**FINAL DRAINAGE REPORT**  
**FOR**  
**LOT 5 OF CLEARWAY**  
**EL PASO COUNTY, COLORADO**

Project #44-042

PCD Project No. PPR-22-034

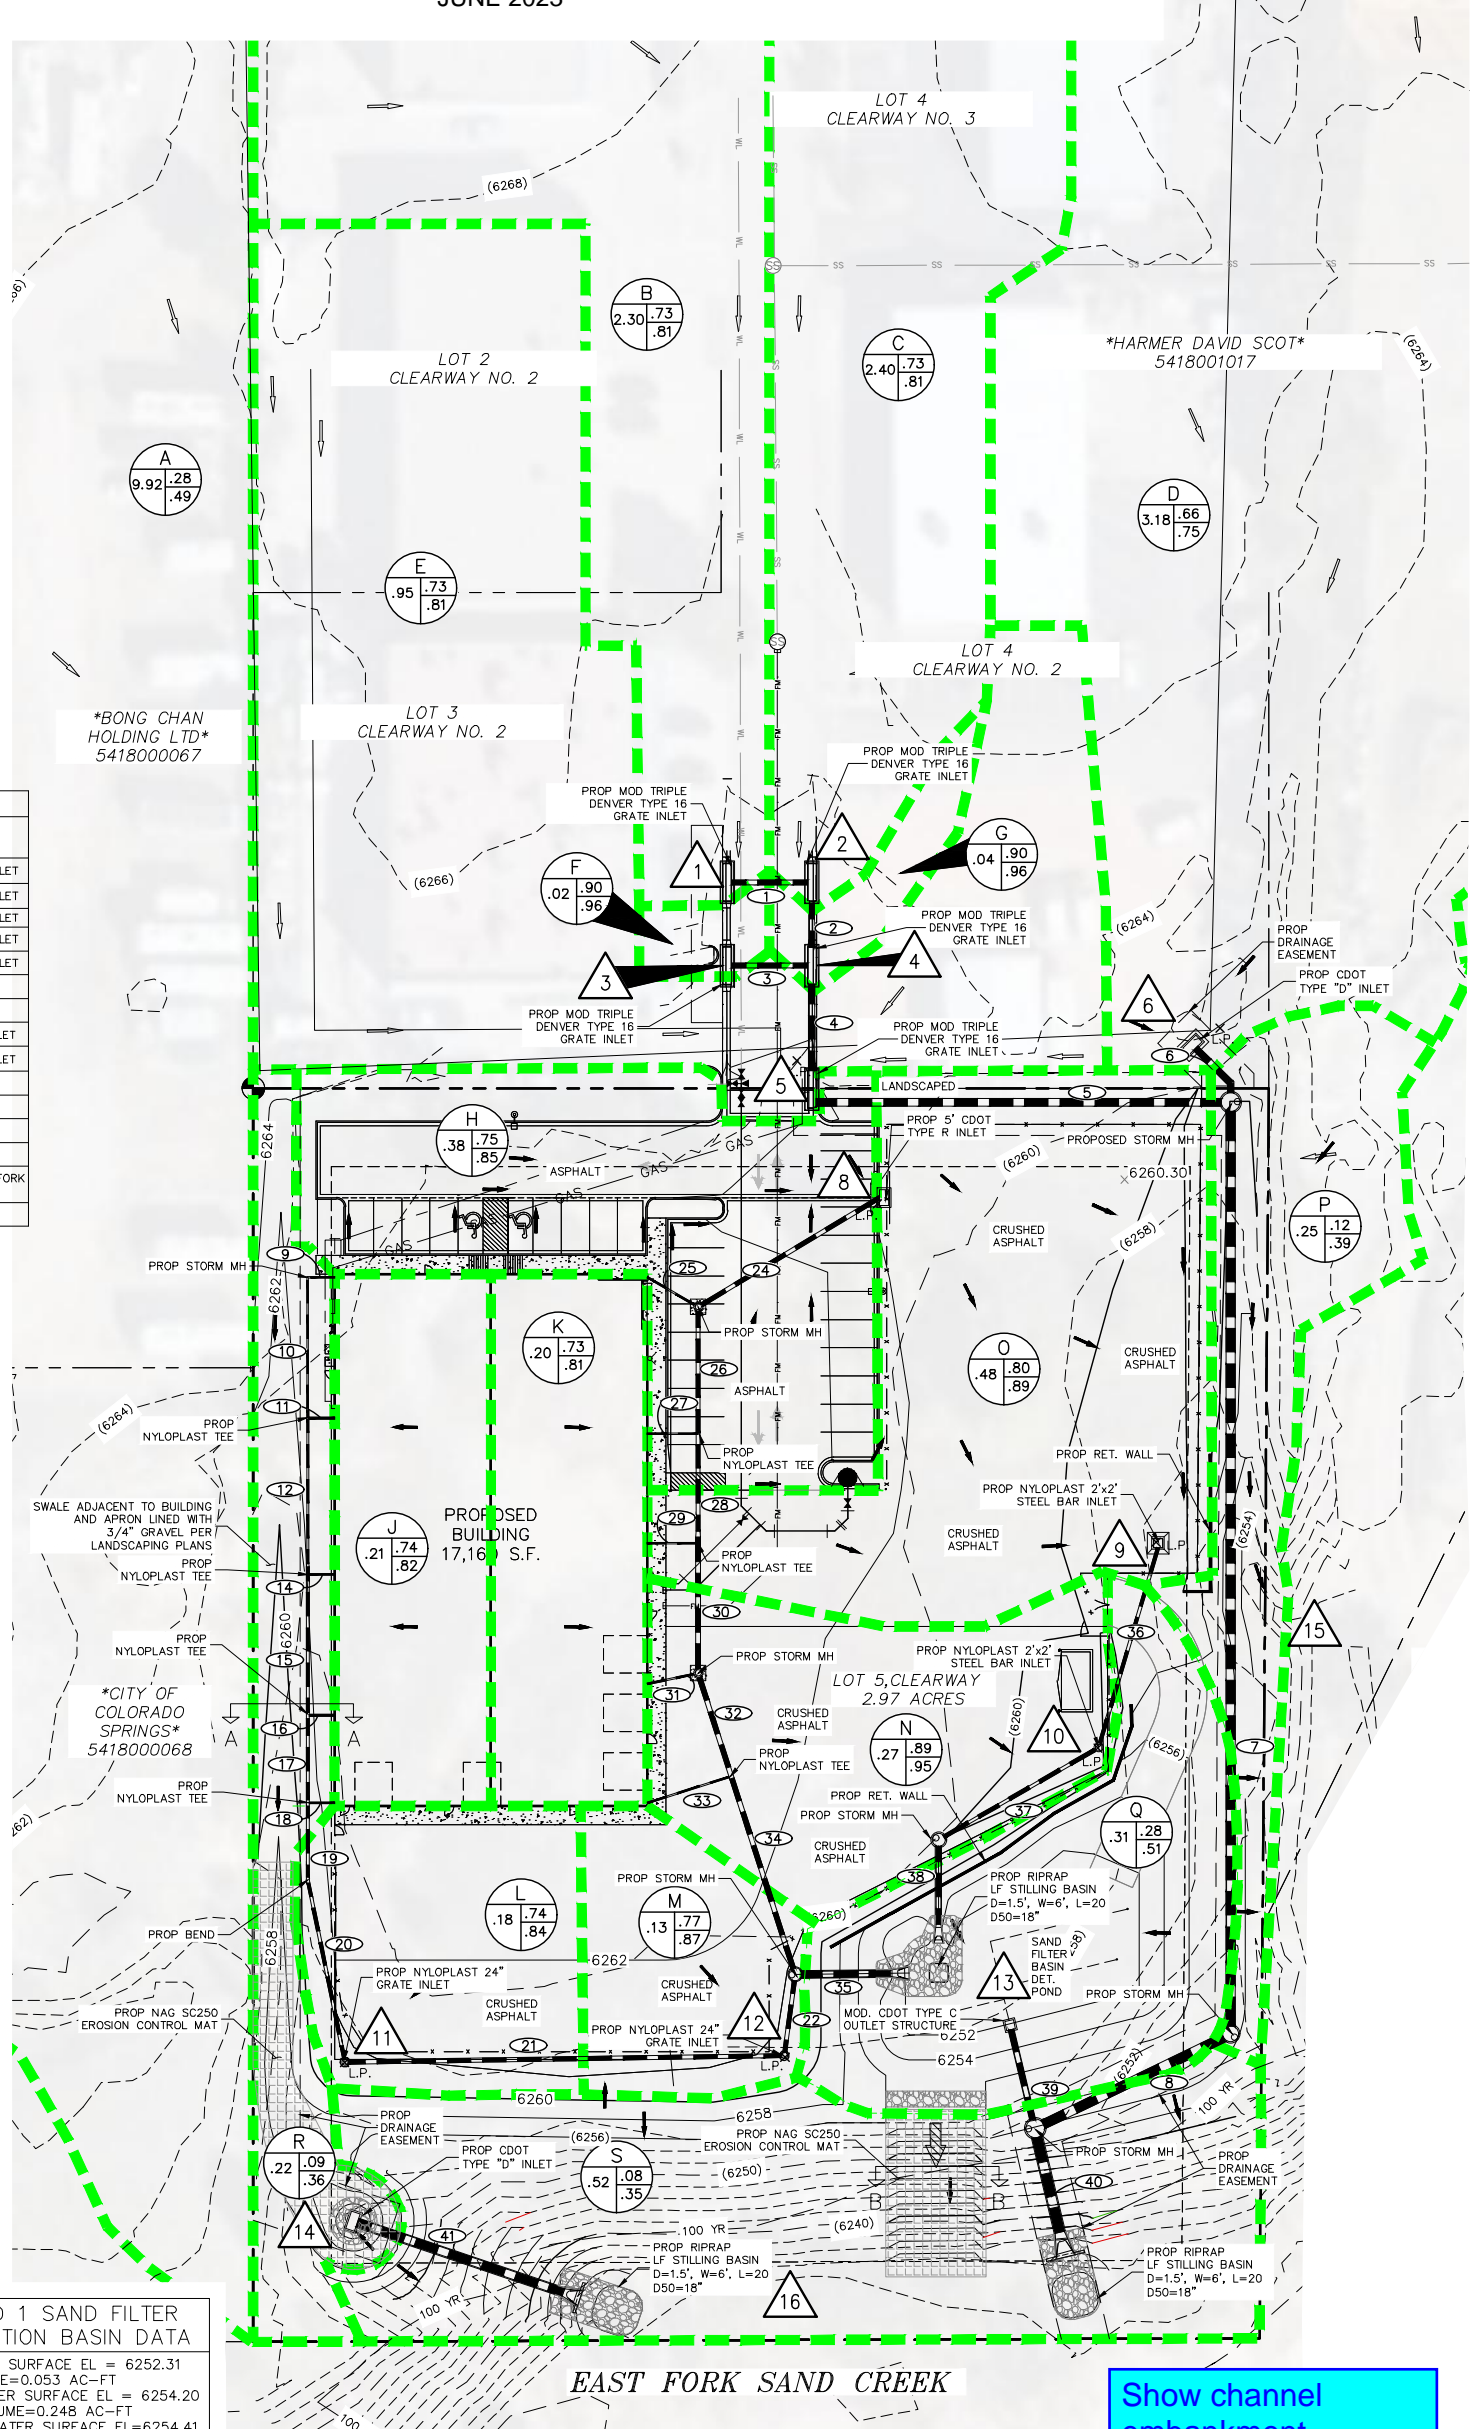
Show channel embankment stabilization area
